Project	IEEE 802.16 Broadband Wireless Access Working Group <http://ieee802.org/16>	
Title	Optional midamble for OFDMA mode	
Date Submitted	Date	2003-11-06
Source(s)	Yigal Leiba Yossi Segal Zion Hadad Itzik Kitroser	Voice: 972-3-9528440 Fax: 972-3-9528805 yigall@runcom.co.il yossis@runcom.co.il zionh@runcom.co.il itzikk@runcom.co.il
	RunCom Technologies LTD. Hahoma 2 St., Rishon Lezion, Israel	
	Soon Yoon Young Samsung Electronics Co., Ltd.	soon.yoon.yoon@samsung.com
	Suwon, Korea	
Re:	Call for Comments: Editor's Draft Consolidation of IEEE 802.16/802.16a/802.16c – (802.16d-03/13)	
Abstract	The document suggests addition of an optional midamble to the OFDMA mode of the IEEE802.16a to enhance performance in broadband channels in a mobile environment.	
Purpose	To adopt these enhancements as additions to the OFDMA mode	
Notice	This document has been prepared to assist IEEE 802.16. It is offered as a basis for discussion and is not binding on the contributing individual(s) or organization(s). The material in this document is subject to change in form and content after further study. The contributor(s) reserve(s) the right to add, amend or withdraw material contained herein.

Optional m

Figure 1: PMP frame structure example with the optional midamble - TDD

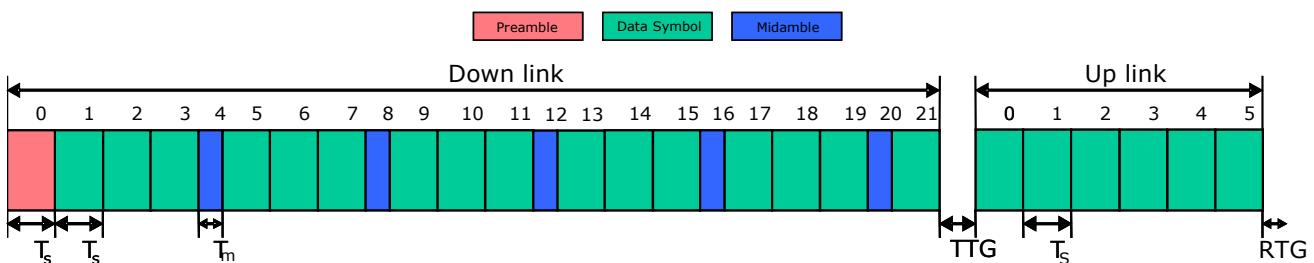
8.5.4.3 PMP frame structure with optional midambles

The basic PMP frame structure described in section 8.5.4.2 can be enhanced for use in broadband channels by use of optional midambles. The midambles are half OFDMA symbol long, and use the same GI as the rest of the OFDMA symbols. The midamble duration is $T_m = (T_s - T_g)/2 + T_g$. The midambles are inserted every third OFDMA symbol not counting the frame preamble.

The midambles presence or is indicated in the DL_FRAME_PREFIX. The preamble is optional in a sense that a BS may support the optional midambels, and an SS may take advantage of its presence, but an SS shall recognize the presence of the midamble and interpret the downlink structure accordingly.

Figure 2: Midamble generation in time domain

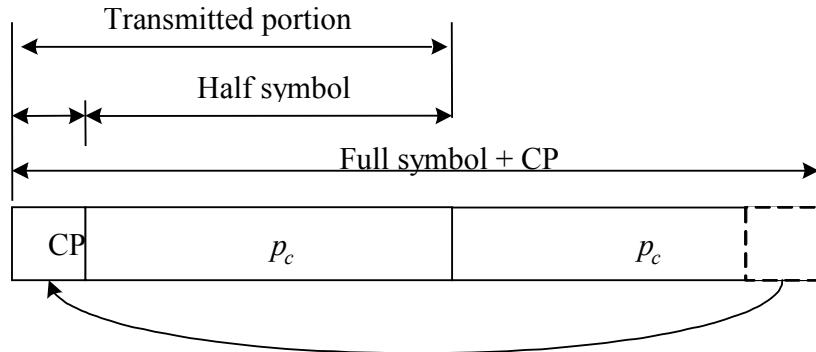
8.5.9.4.4 Pilot modulation for optional midambles

The optional midambles which may be transmitted every three OFDMA symbols in the downlink are half the length of a regular OFDMA symbol, but include a full CP. Figure 2 shows how the midamble is generated.

Figure 3: PRBS structure for preamble and pilot symbol generation

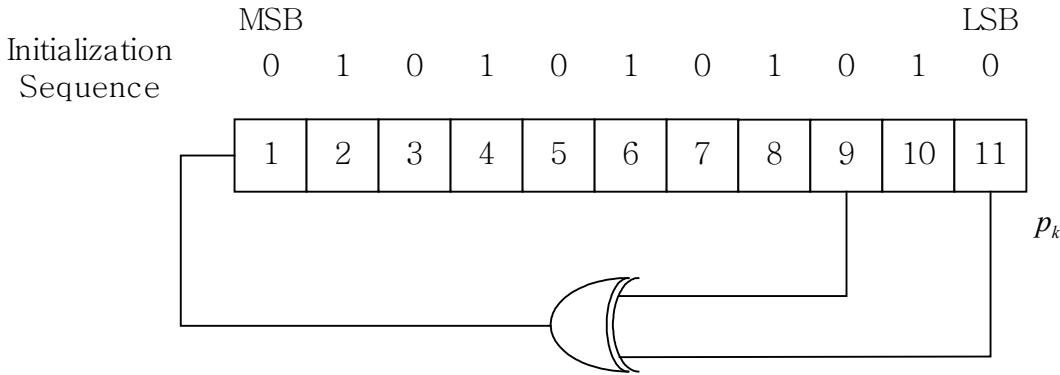
where \oplus denotes the exclusive-OR operator, $w_n^s \in \{0,1\}$ is the n-th value of the s-th codeword in the 8-ary Walsh code set, and p_n is the n-th value of the PN sequence generated from the PRBS shown in Figure 3. The generator polynomial of the PRBS is $X^{11} + X^9 + 1$.

The initialization vector of the PRBS for the preamble modulation is [01010101010].
